**Capital School District
Central Middle School
Interior Renovations
211 Delaware Ave. Dover Delaware 19901
Bid Pac E– Contracts 1 thru 10
October 7, 2024**

Addendum No. 1

ADDENDUM 1

PROJECT: Central Middle to Elementary School Interior Renovation

FIRST FLOOR
ELECTRICAL
LIGHTING PLAN -
AREA D/E

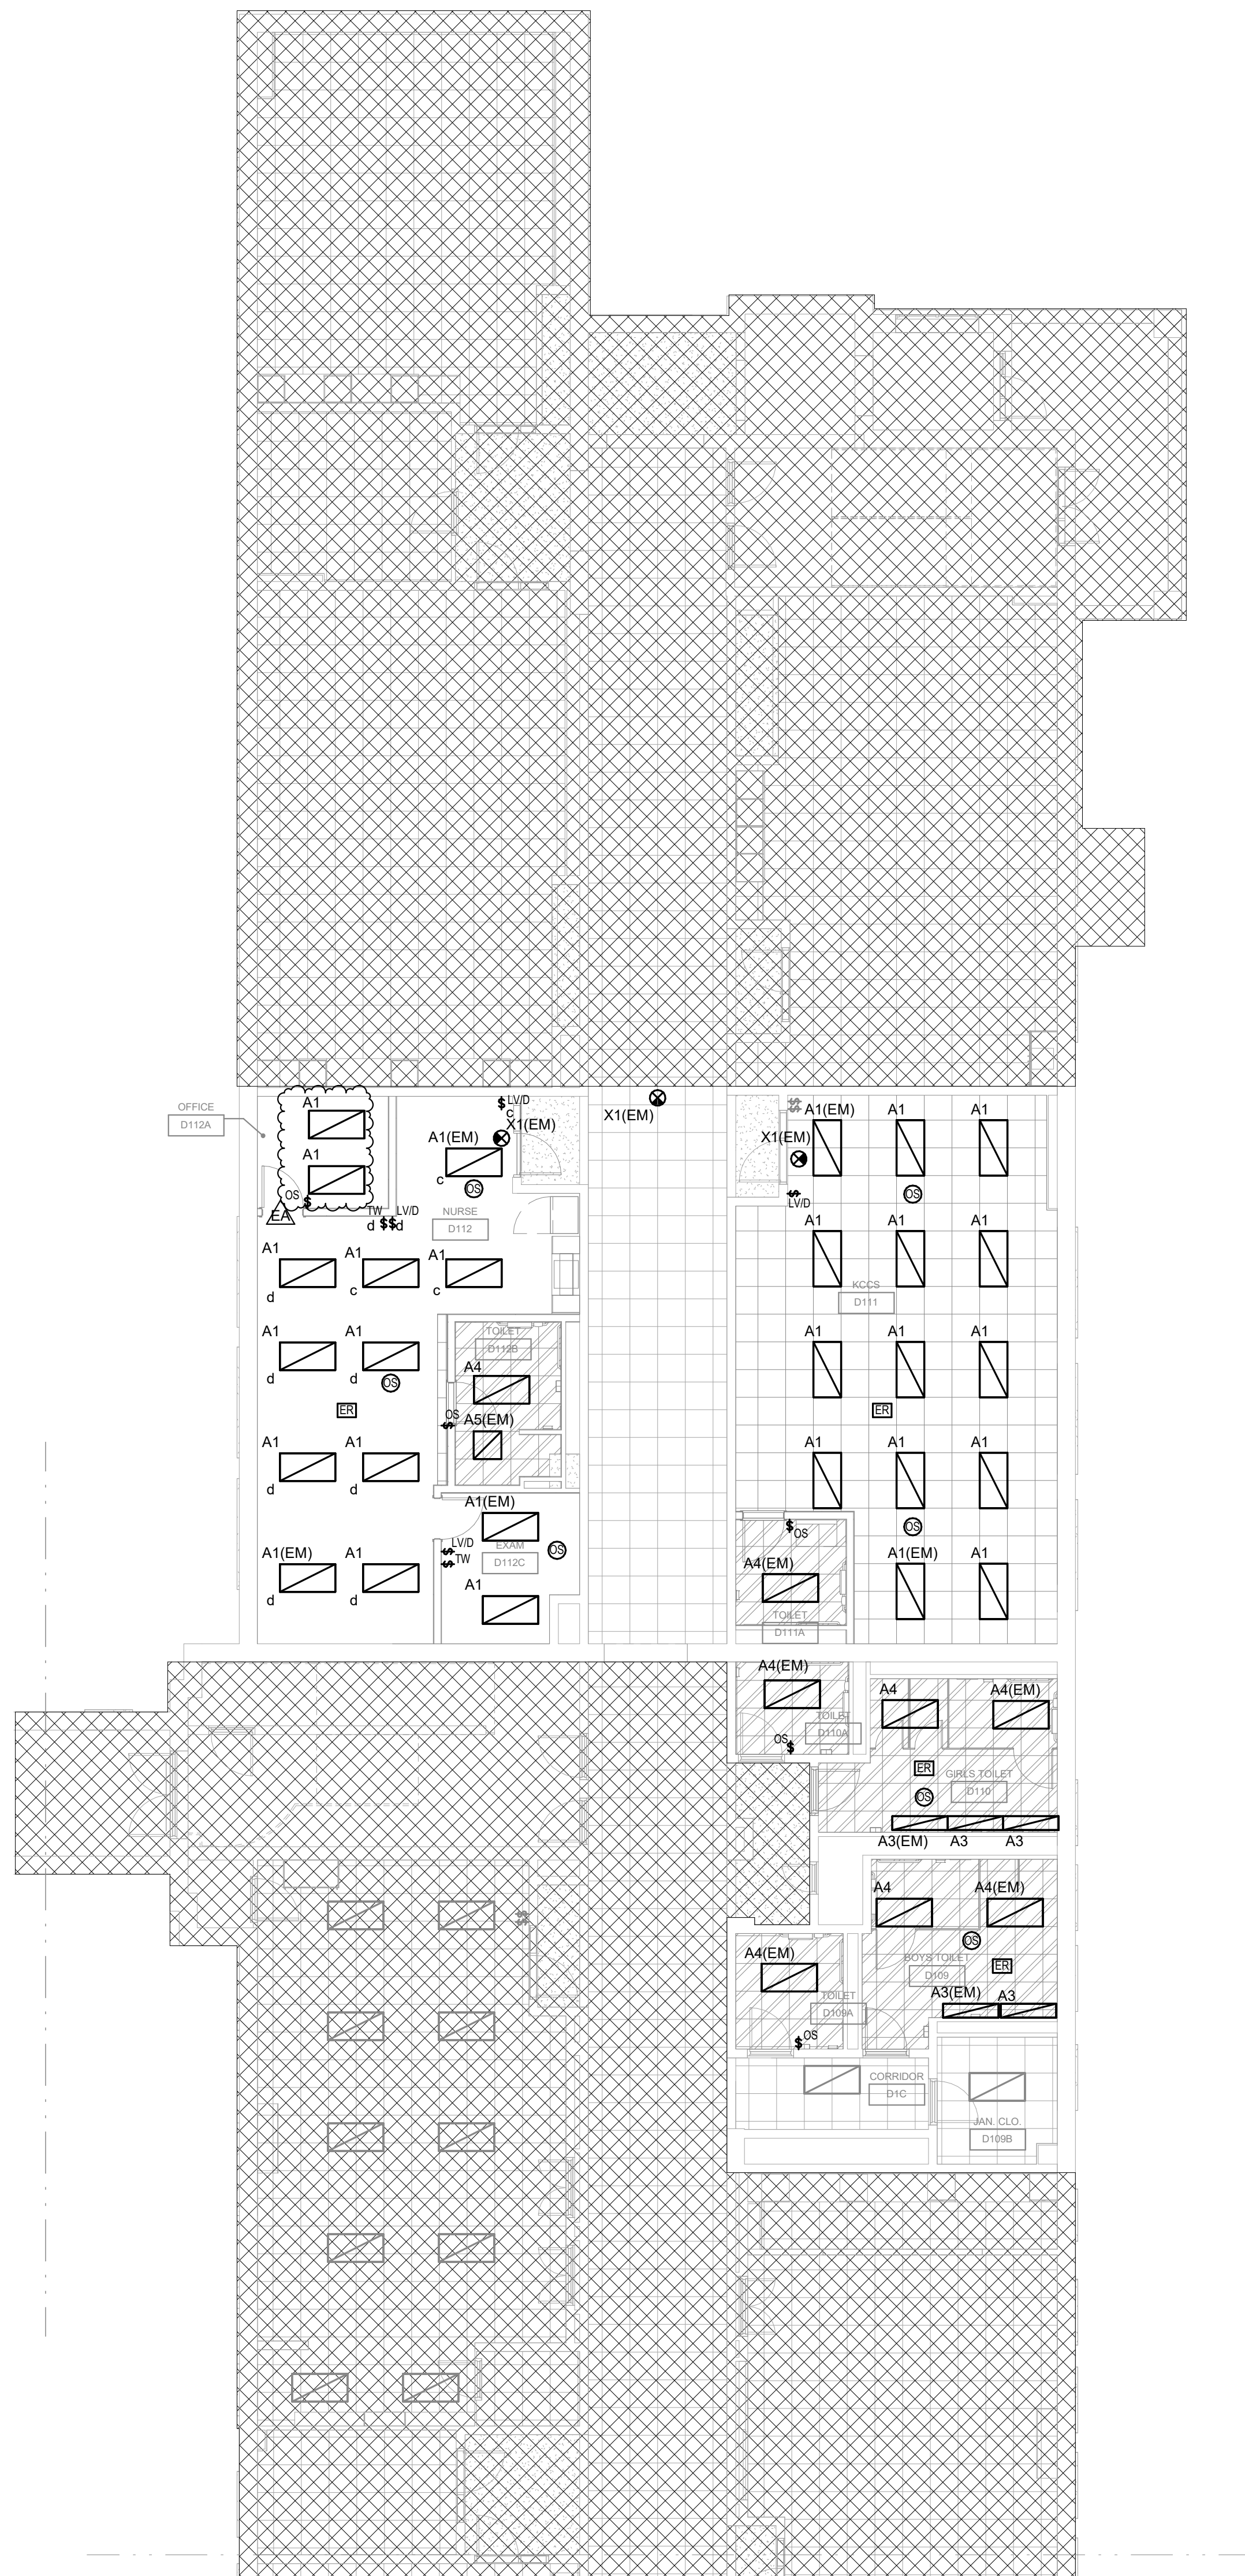
7. E-201D/E – FIRST FLOOR ELECTRICAL LIGHTING PLAN – AREA D/E

- a. **REVISE** lights in grid in Office D112A.
